Access Compliance Report

Public Rights-of-Way

(Curb Ramps)

Intersection ID: 7836	Main Street: SNOW_WHITE_LN	Cross Street: SPRING_GARDEN_LN	Location: SW
ADA ID: 1621508C66CC	Ramp Type: Perp	Initial Pass/Fail: Fail	Overall Compliance: No
Codes/Mitigation Info/Possible Solution		Field Measurements/Component Compliance	
Severity Score: 10

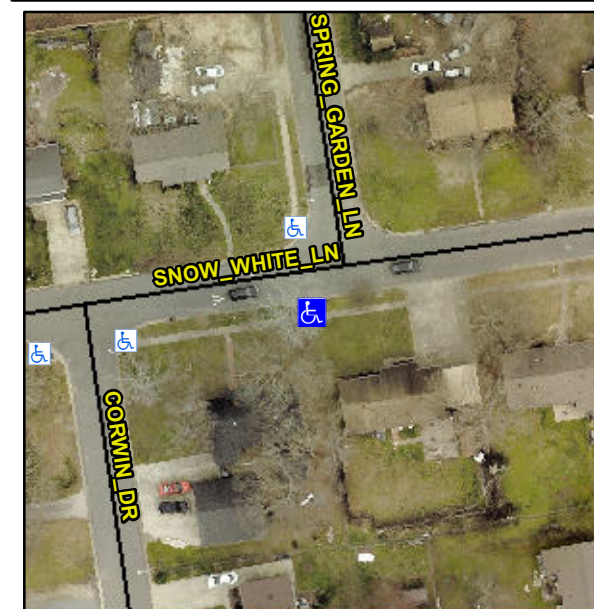
Not Found, R304.5.1

Compliance	Description	Data	Compliance	Description	Data
N/A	Ramp Length (in)	79.0	Yes	Ramp Slope (%)	5.1
No	Ramp Width (in)	44.5	Yes	Ramp XSlope (%)	2.7
N/A	Flare Type LT	N/A	N/A	Flare Type RT	N/A
N/A	Flare Slope LT (%)	N/A	N/A	Flare Slope RT (%)	N/A
N/A	Flare Traversable LT?	N/A	N/A	Flare Traversable RT?	N/A
N/A	Landing Length (in)	N/A	N/A	DWS Provided?	N/A
N/A	Landing Width (in)	N/A	N/A	DWS Contrast?	N/A
N/A	Landing Slope (%)	N/A	N/A	DWS Length (in)	N/A
N/A	Landing X Slope (%)	N/A	N/A	DWS Full Width?	N/A
N/A	Landing Curb? (Y/N)	N/A	N/A	DWS Offset (in)	N/A
N/A	Shared Landing?	N/A			
N/A	Gutter Ponding?	N/A	N/A	Gutter Slope (%)	N/A
N/A	Gutter Lip Ht (in)	N/A	N/A	Gutter X Slope (%)	N/A
N/A	Painted X Walk1?	No	N/A	Painted X Walk2?	N/A
	X Walk 1 Direction	To N		X Walk 2 Direction	N/A
N/A	X Walk 1 Width (in)	N/A	N/A	X Walk 2 Width (in)	N/A
	X Walk 1 Slope (%)	4.6		X Walk 2 Slope (%)	N/A
	X Walk 1 X Slope (%)	3.8		X Walk 2 X Slope (%)	N/A

N/A	Ramp inside XWalk1?	N/A	N/A	Ramp inside XWalk2?	N/A
	Road Slope (%)	N/A	N/A	Clear Space?	N/A
	Road X Slope (%)	N/A	N/A	Clear Space to XWalk (in)	N/A
N/A	Any Obstructions?	N/A	N/A	Storm Grate/Utility Hazard?	N/A
	Obstruction Type			Storm Grate/Utility Type	
		N/A			N/A
			Yes	Surface Condition? (G/P)	Good

Remove & Replace Entire Ramp.
